#### **NOTICE OF NON-PERFORMANCE**

## **INSPECTION REPORT**

Electrical Corporation:	Southern California Edison Company				
Report Number:	CAD_SCE_AXS_20250904_1343				
Inspector:	Alexander Scott				
WMP Year Inspected:	2025				
Quarterly Data Report (QDR) Referenced:	Quarter 1 (Q1)				
Inspection Selection:	Energy Safety viewed the contents of the Q1 QDR and performed an analysis that resulted in the selection of				
	the WMP initiatives and locations referenced in this report.				
Relevant WMP Initiative(s):	8.1.3.1 - Distribution Detailed Inspections and Remediations (IN-1.1)				
Date of inspection:	September 04, 2025				
City and/or County of Inspection:	Palos Verdes Peninsula, Los Angeles County				
Inspection Purpose:	Assess the accuracy of Southern California Edison Company's QDR data, completeness of its work, compliance				
	with WMP requirements, and compliance with its protocols.

Deficiency 1

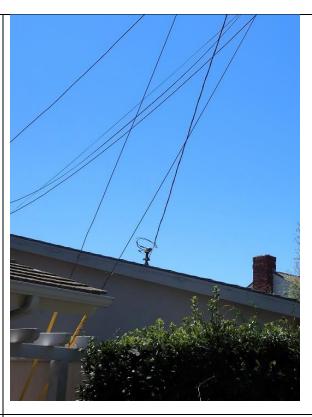
On Pole ID 1232593E, Grid Hardening ID 412152966-1232593E at 4200-4236 Via Alondra, Palos Verdes Peninsula, CA, 90274, USA, 33.796231, -118.360156, the inspector observed that the down guy wires were loose. The inspector's observation is documented in Deficiency 1 photographs, which are attached to this report. Photo numbers IA1Img1 and IA1Img2 depict loose guy wires. Per information provided by SCE to the Compliance Inbox on July 1, 2025, at 4:09 pm, the remediation work was completed.

- 1. Southern California Edison Company's 2025 WMP initiative number 8.1.3.1 Distribution Detailed Inspections and Remediations work identified that tightening of the guy wire was completed at this location.
- 2. The guy wires were loose.

IA1Img2: View showing down guy not tightened

Deficiency 1. Energy Safety observed that in implementing 2025 WMP initiative 8.1.3.1 - Distribution High Fire Risk-Informed (HFRI) Inspections and Remediations (IN-1.1), SCE failed to complete the remediation of tightening a guy wire on Pole ID 1232593E, Grid Hardening ID 412152966-1232593E at coordinates 33.796231, -118.360156. Energy Safety considers this non-performance to be in the Minor risk category. SCE must complete a corrective action for this deficiency by 12 months from date of this notice.
